## Programmed Repairs Engines 602.96, 603.96/97 Combustion

### 07.1 Diesel Injection System

P07-6354-13

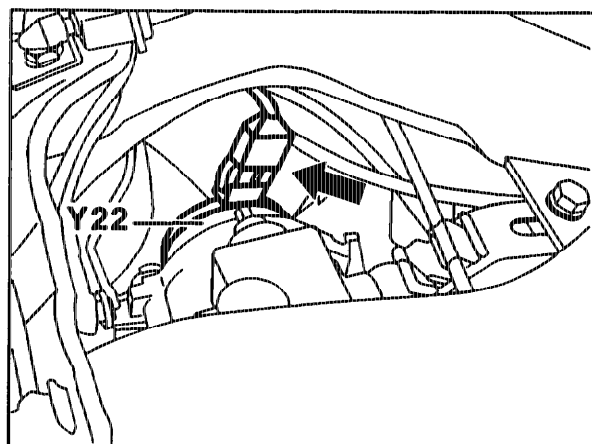
Engine surges when idling

Unplug 2-pin connector (arrow) at servomagnet (Y22).

If engine runs properly, check idle speed and set, if necessary, to  $580 \pm 20$  rpm.

Install modified control module part no. 006 545 36 32 and plug in 2-pin connector again.

P07-6357-13

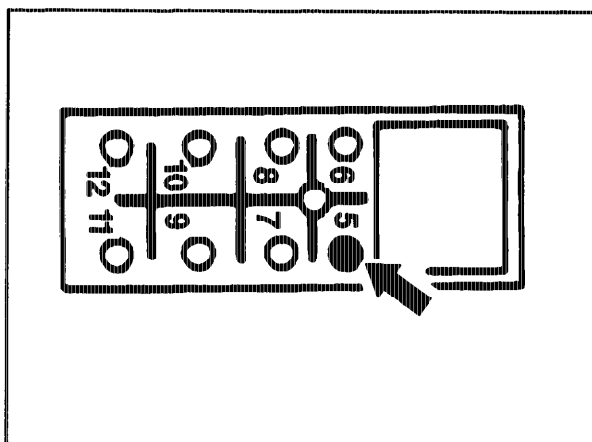
Coding bridge of old control module must not be plugged into the new control module.

When inserting the new control module, pierce the non-assigned contact 5 in the connector (arrow).

P07-6356-55

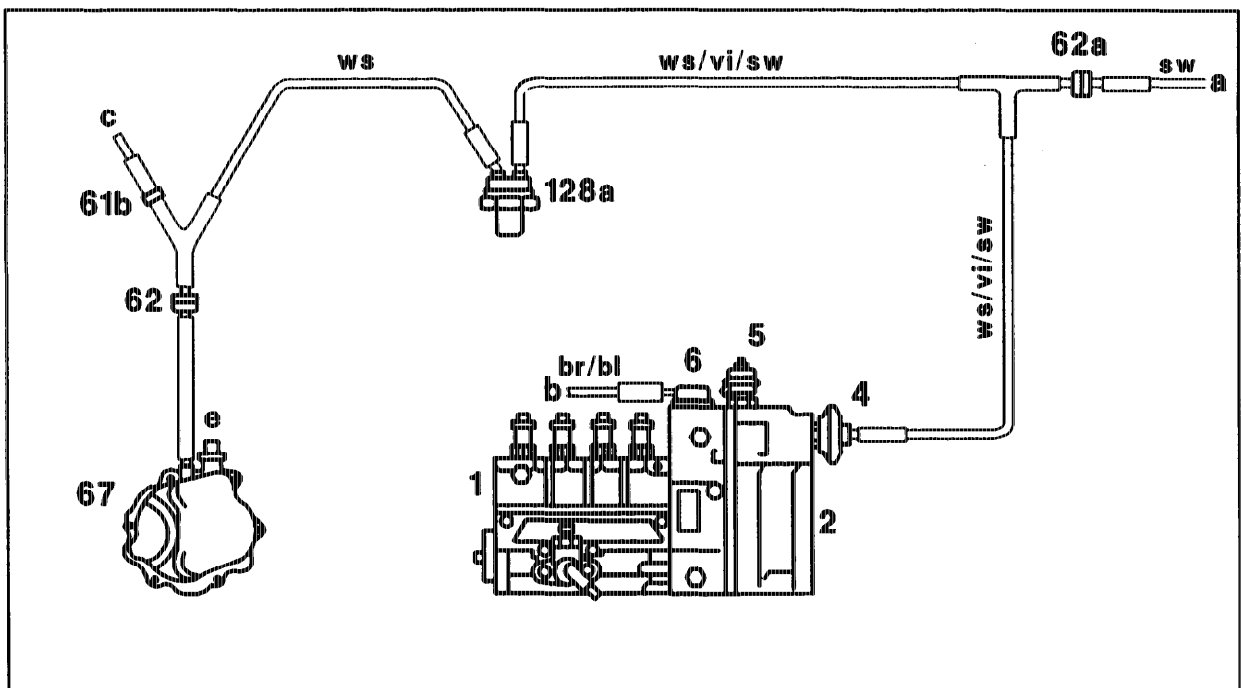
Engine cannot be switched off or not easily.

- Vacuum hose and vacuum pump (67) may be split.
- Filter (62) blocked or leaking.
- Restrictor (61b, orange) may be blocked.
- Vacuum of vacuum pump not sufficient. Check vacuum at ancillaries connection. Specification when engine idling after 30 s at least 700 mbar.

P07-6355-13

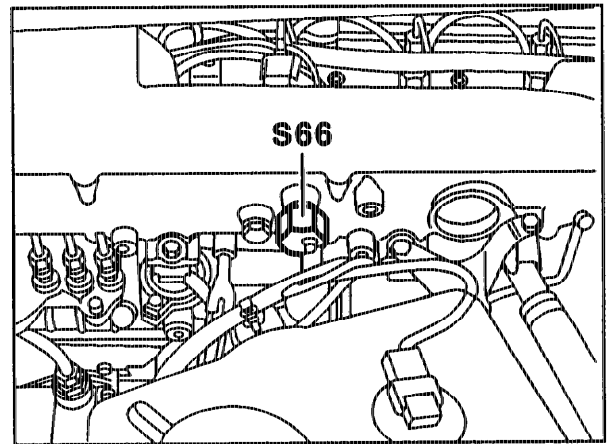
Engine misfires at full load from 2000 rpm

Boost pressure too high or engine overload protection activated too soon.

Test boost pressure with connector unplugged from engine overload protection switch (S66).

If boost pressure  $> 0.95$  bar, boost pressure control valve of turbocharger faulty. Replace turbocharger.

If boost pressure  $< 0.95$  bar, switch engine overload protection (S66) reacting too soon. Replace switch (S66).

P43-2001-13

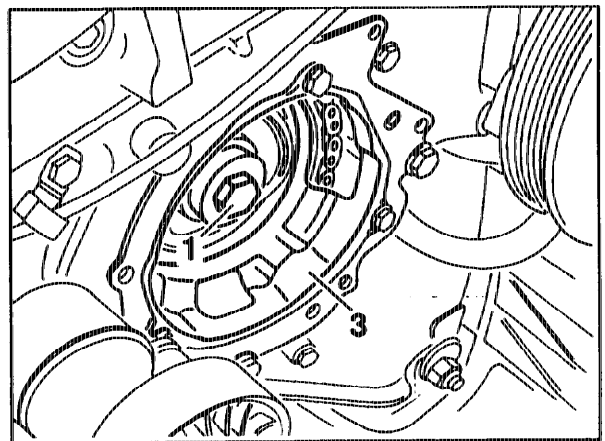
**Engine cannot be switched off when cold (was SI 07.1/37 and 43/6)**

Damaged piston vacuum pump (model up to May 1986).

If this problem exists on models manufactured prior to this date, which do not have a second drilling in the oil spray nozzle for the oil supply of the piston vacuum pump, or for performing work which requires taking off the vacuum pump, remove the centering sleeve and install in modified seal for improving the oil supply.

- 1 Remove flange shroud, fan and belt (see Repair Instructions Group 13, Op. No. 342).
- 2 Remove piston vacuum pump (see Repair Instructions Group 43, Op. No. 618).
- 3 Remove centering sleeve (3). It must no longer be installed.

P43-2002-13

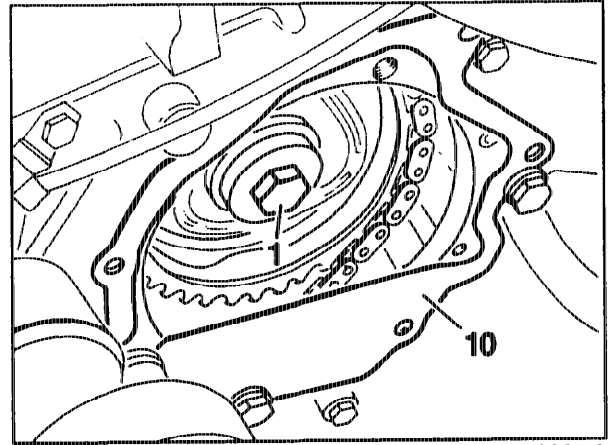
- 4 Install modified seal (10) in place of the previous one.
- 5 When dealing with the problem mentioned above, install new vacuum piston pump.
- 6 Do not connect vacuum pipes to the brake unit at the piston vacuum pump at this stage.
- 7 Install V-belt, fan and fan shroud.
- 8 Run engine and pour about 50 cm<sup>3</sup> engine oil into the piston vacuum pump through the open vacuum connection with an oil spray can.

P07.11-0003-02

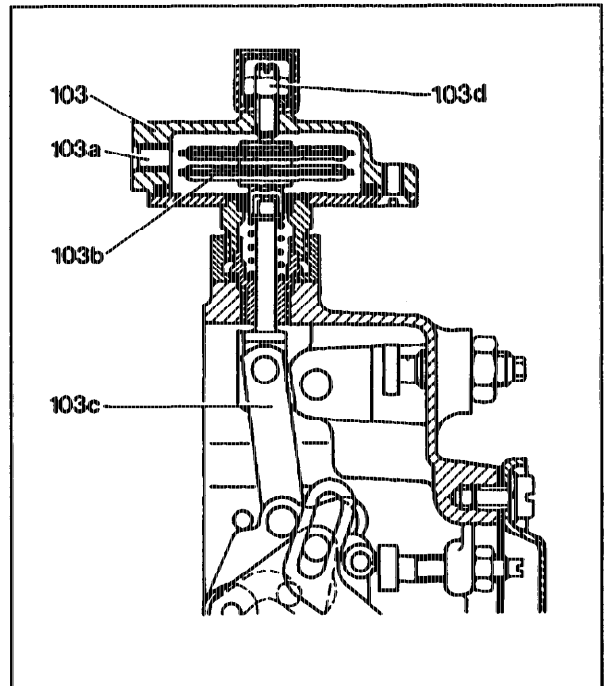
Sluggish acceleration when engine cold up to about 2000 rpm

- a) Full load stop not correctly set.
- b) Insufficient full load quantity.

- a) Check setting of accelerator control linkage, adjust (see RA30-1010).
- b)
  - 1 Remove boost air pipe, install (see RA14-1310).
  - 2 Set full load quantity at barometric pressure compensation unit:
    - Take off cap (black) on barometric pressure compensation unit (103).
    - Slacken lock nut (103d).
    - Use a screwdriver to turn setting screw about 1/4 turn to the left.
    - Tighten lock nut (103d).
    - Fit on cap.

P07.11-0001-15

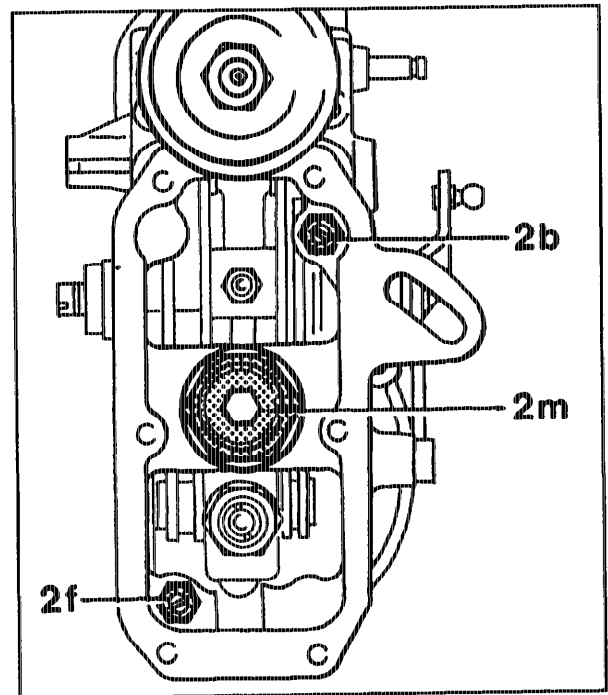
8 Increase full load quantity.

- Turn slotted screw (2f) about 1/4 turn to the  
left.

P07.11-0002-15

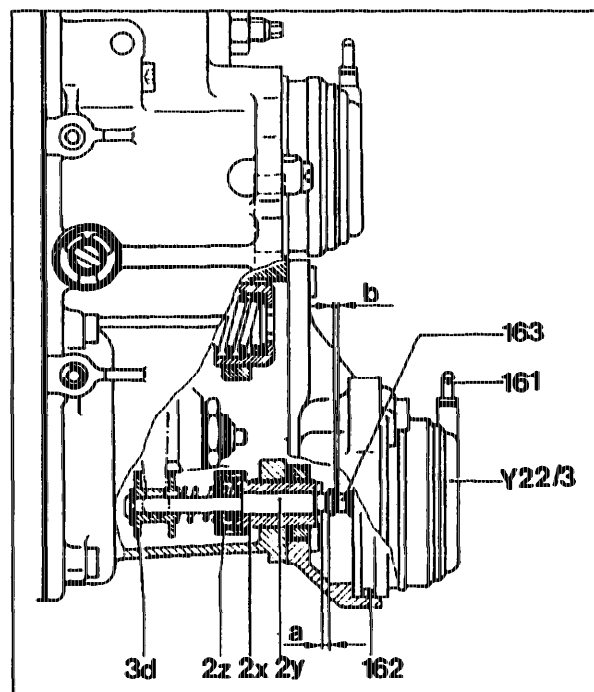
- Slacken lock nut of sliding pin (2y).
- Turn sliding pin (2y) about 1/4 turn to the left.
- Tighten lock nut of sliding pin (2y).
- Bolt on flange and insert servomagnet (Y22/3) without O-ring (162).

When inserting servomagnet, no resistance should be felt; shorten lift rod (163) of servomagnet (Y22/3) up to max. 0.3 mm if necessary.

- Install servomagnet (Y22/3) with O-ring (162).
- Check injection pump for leaks.
